## ***Interactive comment on “Accurate stream extraction from large, radar-based elevation models” by M. Metz et al.***

**S. Grimaldi**

Received and published: 7 June 2010

**Figure 1:** Rigo Basin (84 Km<sup>2</sup>), Italy

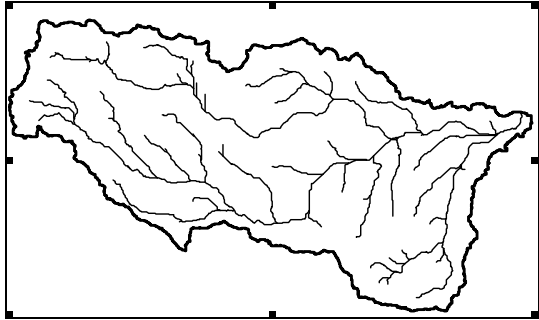
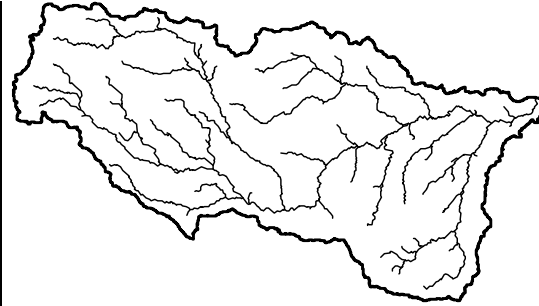
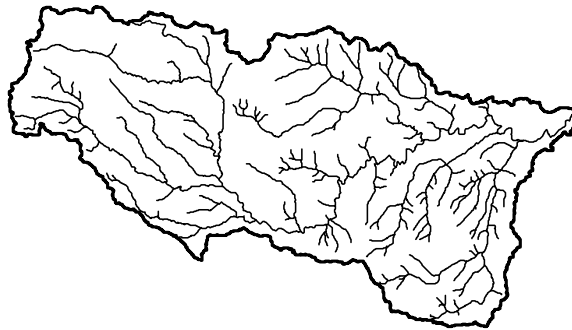
Comment n.3 The evaluation of the obtained blue lines is an other hot topic. Authors have available around 1200 observed points to judge DEMs with million cells and probably this information is not enough to conclude that a method is better than another one. In the figure 1 (here showed at the end of this comment text) there is an example to clarify this point. We have a digitized map and two blue lines obtained by two different extraction methods. I am sure that if we compare the performance using observed

points we could be not able to see the macro-differences among the drainage networks showed in the figure. Consequently the suggestion is to evaluate the obtained blue lines estimating the morphometric and geomorphologic parameters: Horton parameters, flow length, meandering properties...indeed in general it is more important that an extraction procedure is able to provide a realistic blue line (hydrologically speaking) instead to provide a blue line near the observed points not reproducing a good pattern.
